**LEXINGTON-FAYETTE URBAN COUNTY  
 GOVERNMENT CONTRACT CHANGE ORDER**  
 Page 1 of 2

Date:	<b>April 19, 2016</b>
Project:	Idle Hour Park Improvements
Location:	Lexington
Contract No.	242-2015
Original Contract Amt.	\$479,230.00
Cumulative Amount of Previous Change Orders	\$159,497.35
Percent Change - Previous Change Orders	33.28%
Total Contract Amount Prior to this Change Order	\$638,727.35
Change Order No.	<b>2</b>

PROJECT: Idle Hour Park Improvements

CHANGE ORDER NO. 2

Figure 1: Approximate Area of Observations

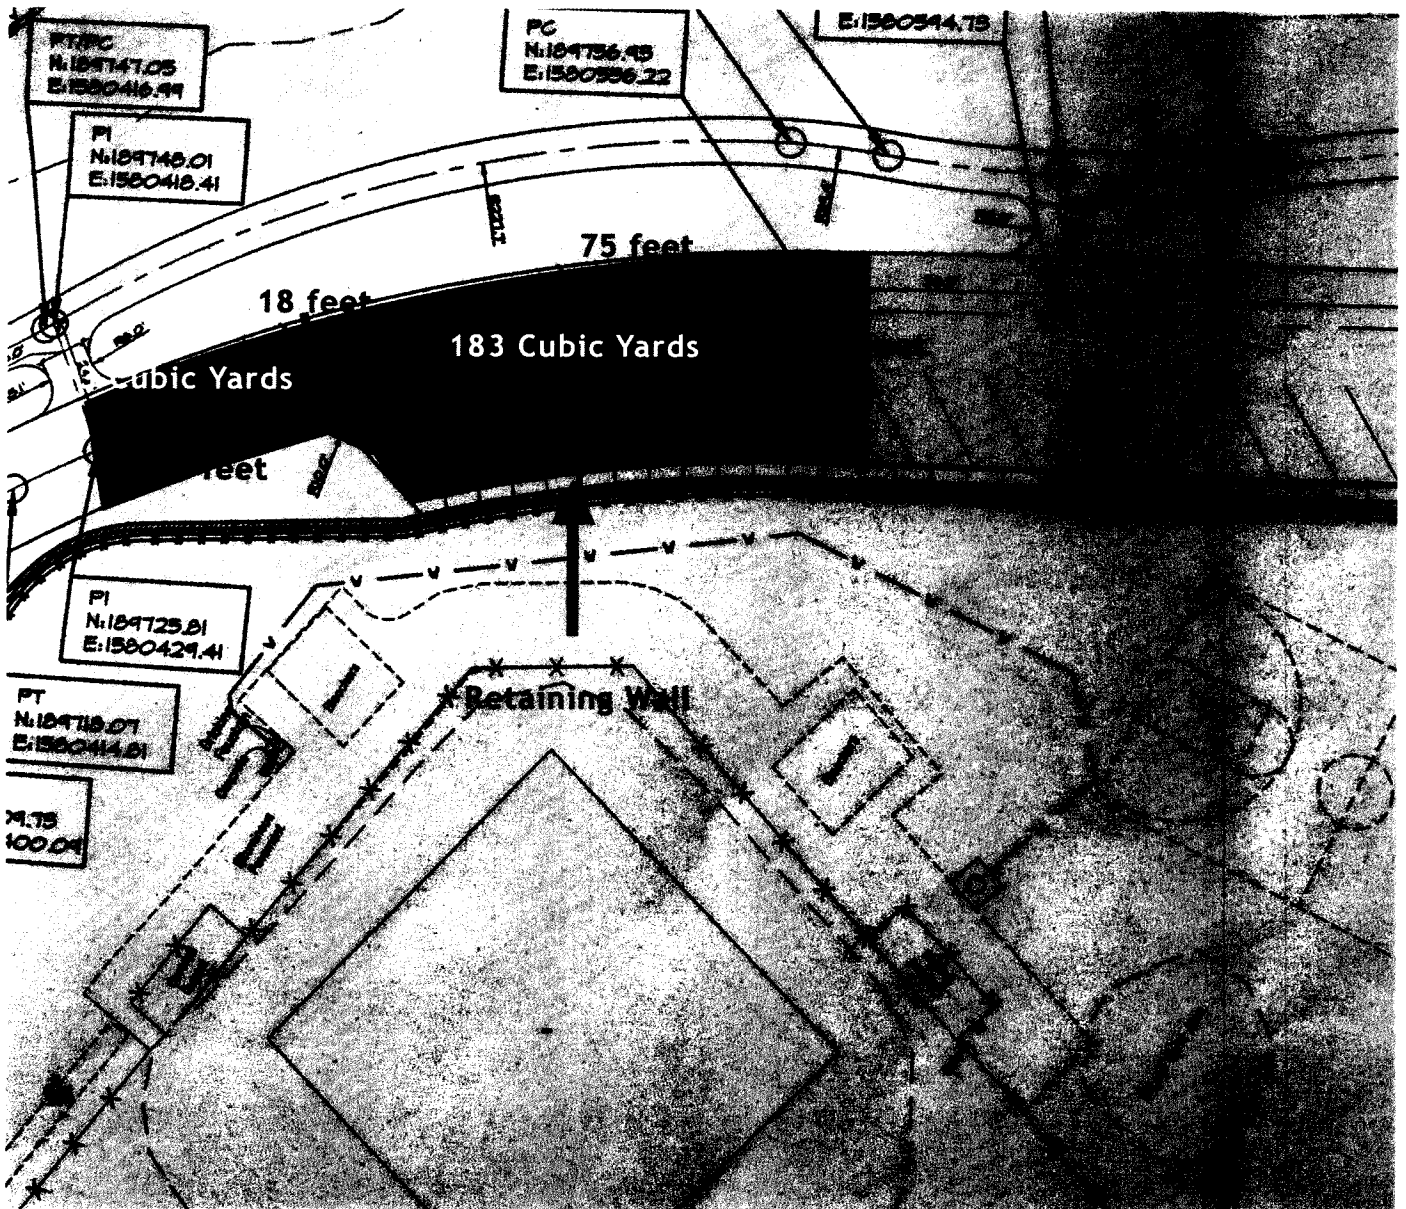
The proof roll revealed soft pumping material throughout the roadway beginning at the end of the existing asphalt roadway to 130 linear feet. The pumping was evident throughout the full width of the proposed roadway and through the proposed Keystone retaining wall area. The remaining portion of the proposed roadway revealed minimum deflection.

The soft pumping area measured to be 75 feet by 33 feet and 55 feet by 18 feet. A test pit was excavated to determine the depth of the soft material. The test pit was advanced down to a depth of two feet with no bearable material encountered through this point. An estimated 256 cubic yards of material was measured to be excavated out, as shown Figure 1.

Based on our reconnaissance of the site and our understanding of the project we believe the soft soils encountered will not support the proposed construction and will need to be stabilized to facilitate the construction above the subgrade. Such stabilization can be achieved by undercutting the soft materials down two feet, lining the soft area with a reinforced geotextile fabric and backfilling with a #2 stone like aggregate back up to the designed subgrade elevation. Once the stabilization has occurred the area should be evaluated by proof rolling to verify stability prior to placement of the pavement section or Keystone wall.

Description of Change: Provide pricing to remediate existing subgrade conditions uncovered at new parking lot area. NOTE- extend remediation 5' to each side of parking area beyond dimensions indicated on attached to avoid failure at pavement edges.

Per attached, provide pricing to overexcavate 24" below proposed pavement section, install Tensar BS 1200 or similar approved product, backfill with #2 stone to design subgrade. Utilize Contract Unit Prices for applicable work.

Below is our pricing to perform the undercut of unsuitable material for the roadway and retaining wall as detailed in the CSI report dated April 6<sup>th</sup>, 2016. I have adjusted the quantities based on CSI recommendation to undercut five (5) feet outside the edge of the roadway and include undercut under the retaining wall.

408 CY Unsuitable Soil Removal @ \$26 CY = \$10,608.00  
530 TN #2 Stone @ \$28/TN = \$14,840.00  
612 SY BX1200 @ \$3/SY = \$1,836.00
